## Exhaust System Buzz at 1,800 rpm (Supersedes 94-041, dated November 28, 1994)

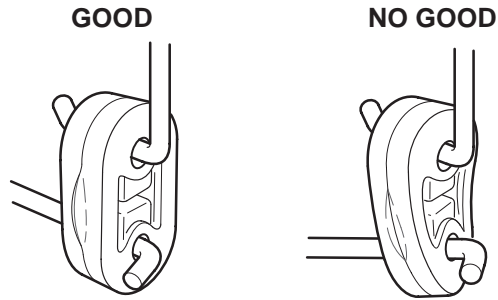
Replace the gaskets (see PARTS INFORMATION) at both ends of the mid-pipe. Use new mounting hardware.

1. Remove the four bolts mounting the mid-pipe to the catalytic converter and exhaust pipe A.

NOTE: Some models have the heated oxygen sensor mounted in the mid-pipe. Do not damage it while doing this repair.

2. Remove and discard the old gaskets.
3. Install the new gaskets.
4. Reinstall the mid-pipe to the catalytic converter and exhaust pipe A with the new bolts, nuts, and springs from the kit. Torque all four nuts to 22 N·m (16 lb-ft).
5. Examine the exhaust pipe hangers; make sure they are sitting vertically.

Exhaust mid-pipe fastener kit:  
 P/N 18010-SV4-305, H/C 5027362  
*(Kit contains two gaskets, four flange bolts, four springs, and four self-locking nuts.)*
